# Access Compliance Report
# Public Rights-of-Way
# (Curb Ramps)

**Main Street: BANTA_AVE** | **Cross Street: ENDRY_ST** | **Location: NW**

**ADA ID: RPAT210916085301** | **Ramp Type:Type 1 - Perpendicular Diagonal Initial Pass/Fail: Fail** | **Overall Compliance: No** | **Severity Score: 35**

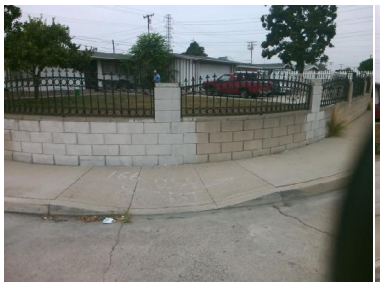
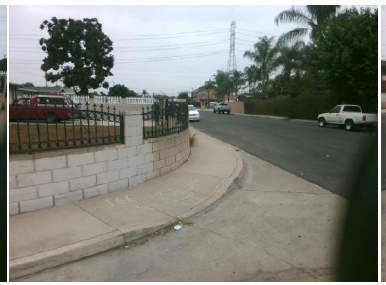
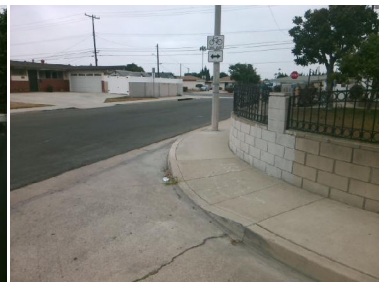
**R304.5.1, R304.2.2, R304.5.3, STD 1115**

| Compliance | Description | Data | Compliance | Description | Data |
|---|---|---|---|---|---|
| **No** | Ramp Width (in) | **37** | | | **N/A** |
| **No** | Ramp Run Slope (%) | **12.2** | **N/A** | Flare Slope LT (%) | **N/A** |
| **No** | Ramp Cross Slope (%) | **4.4** | **N/A** | Flare Traversable LT | **N/A** |

**Remove & Replace Curb Ramp With Two New Directional Ramps or Equivalent.**
